**ADDENDUM NUMBER TWO**  
**Erwin Riverfront Marina Parking Lot**  
**Proposed Paving at Parks Maintenance Building**  
**FOR THE CITY OF CHATTANOOGA, TENNESSEE**  
**Contract Number R-16-015 / R-17-002**

QUESTIONS HAVE BEEN RECEIVED ABOUT THE PAVING AT PARKS MAINTENANCE OFFICE ON MIDDLE STREET

PROPOSED LOT PAVING  
PARKS MAINTENANCE BUILDING  
DUMPSTER CORRAL DETAILS

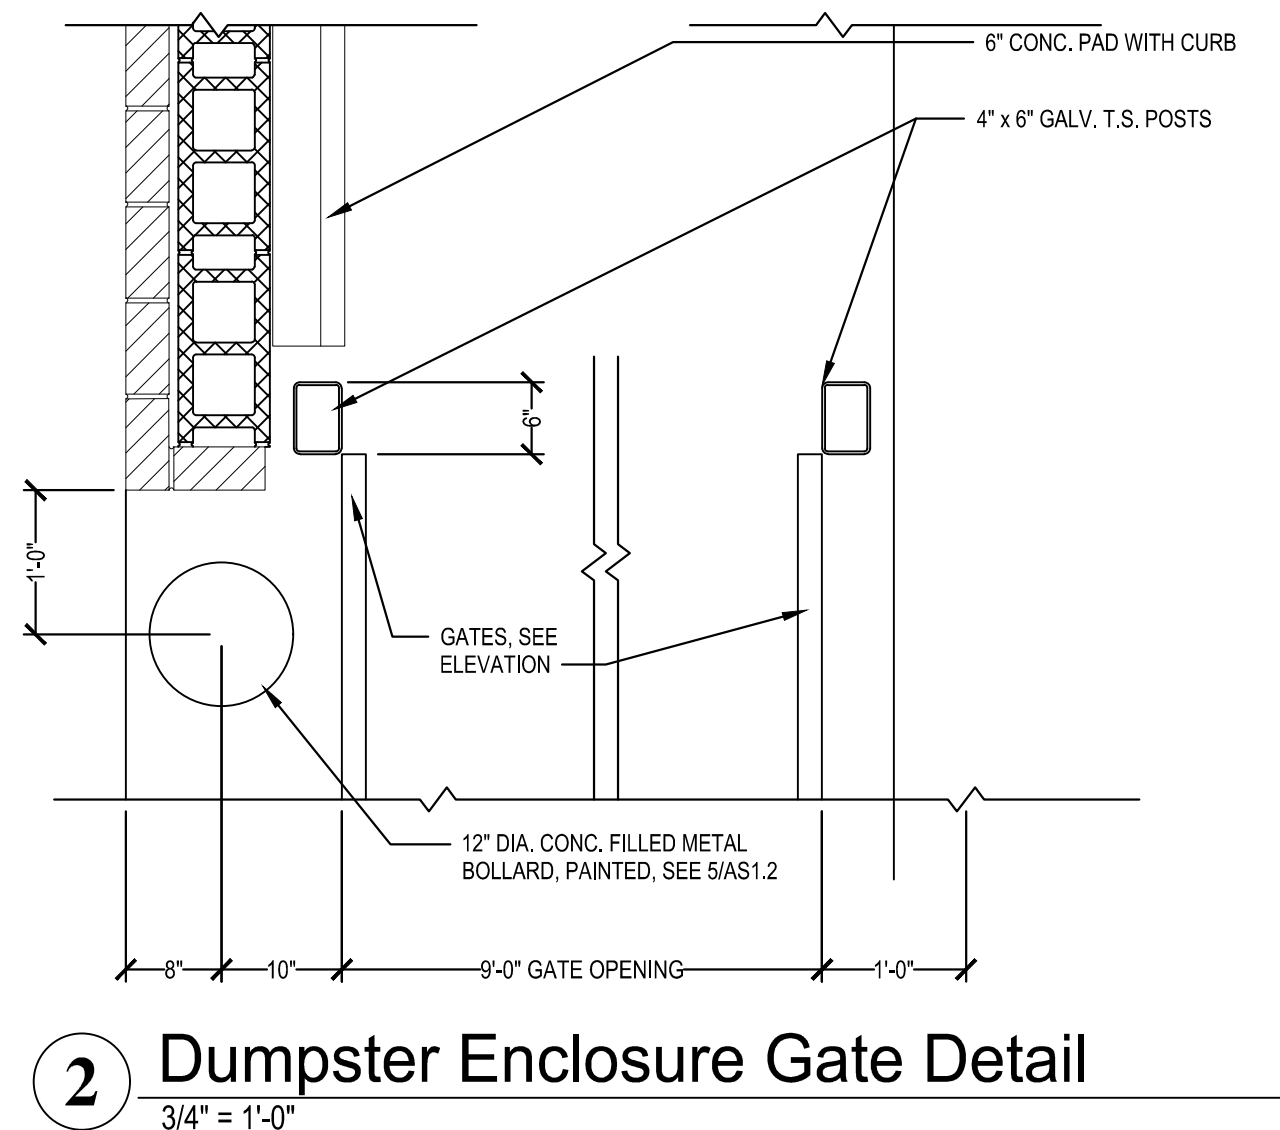
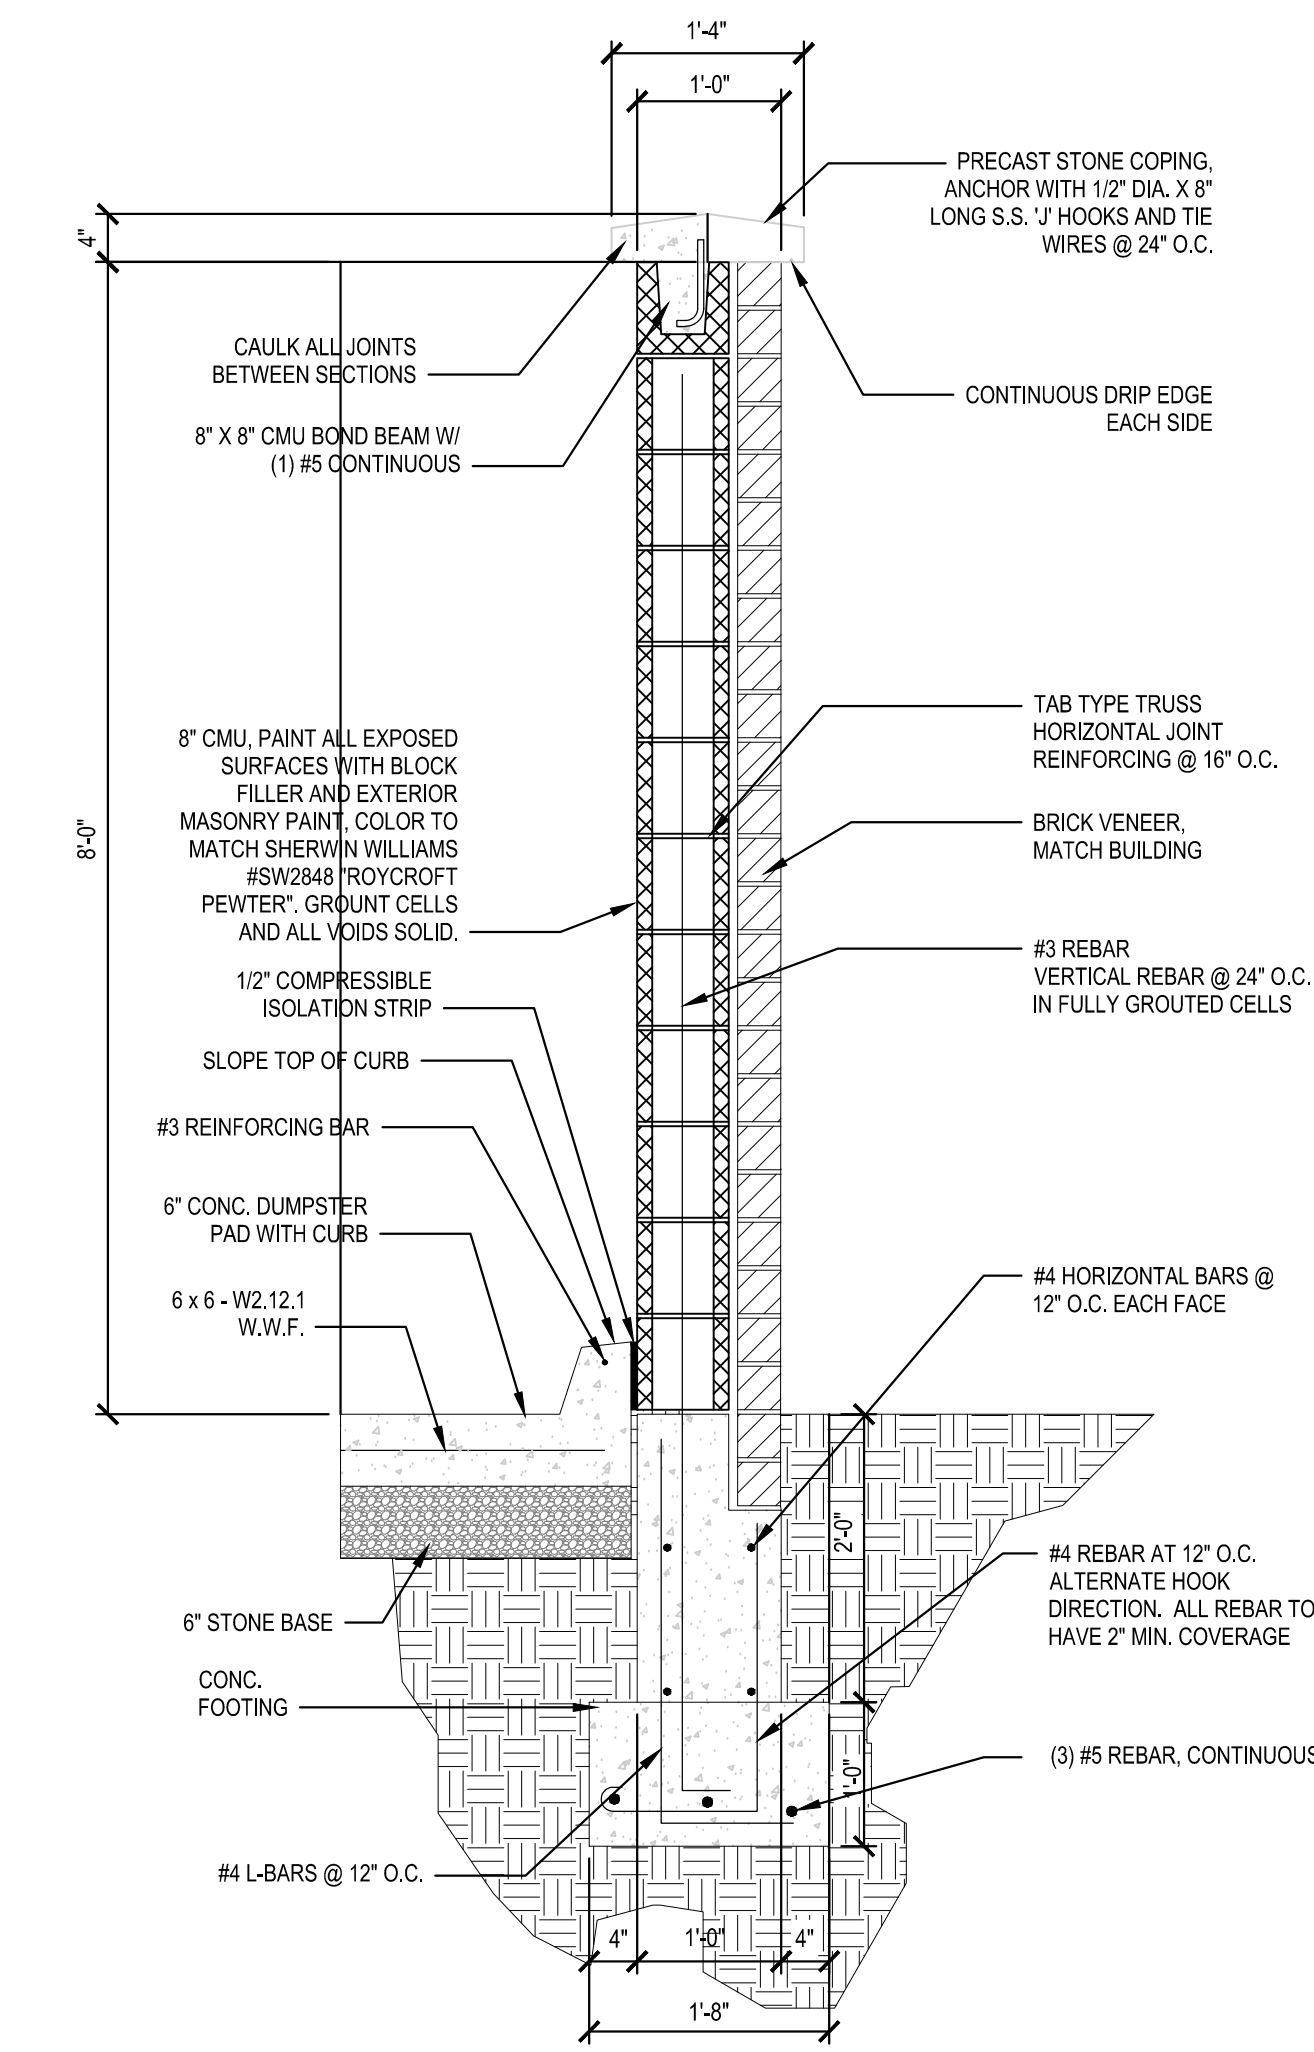
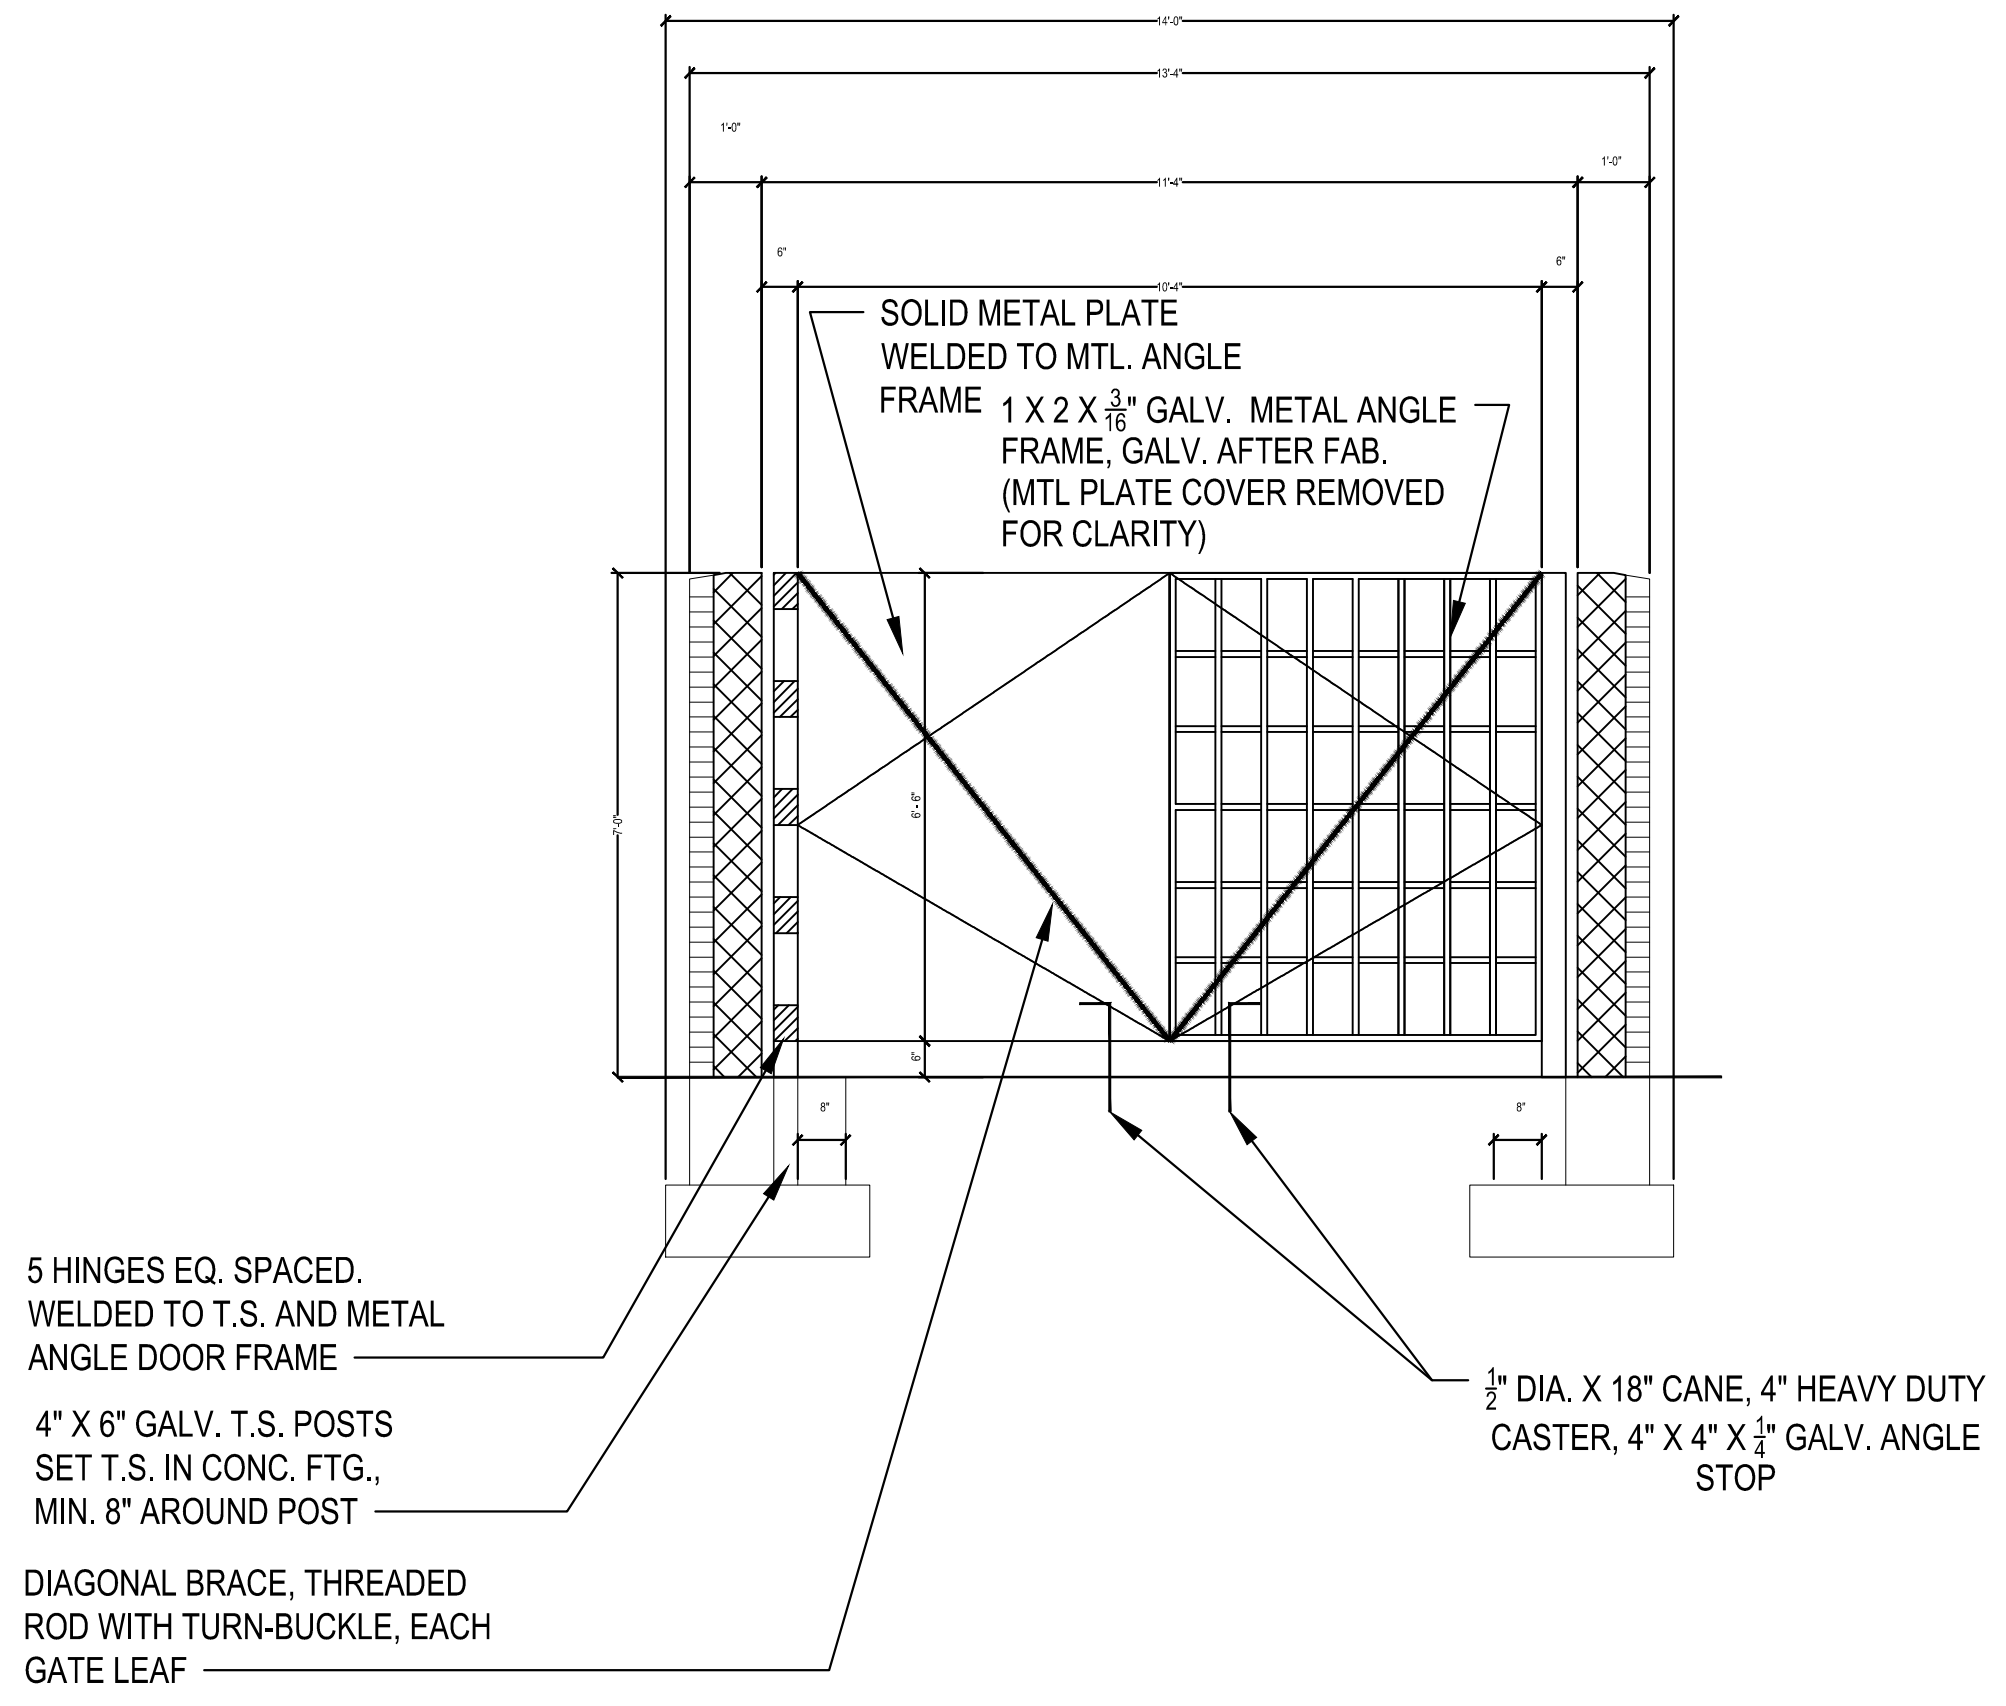
**Q1. Detail 1 on Dumpster Corral drawings: Can we get some dimensions from outside to outside of the block**

A1. Front to back measurement is 10'-0". Width is 12'-8". See attached drawing revision.
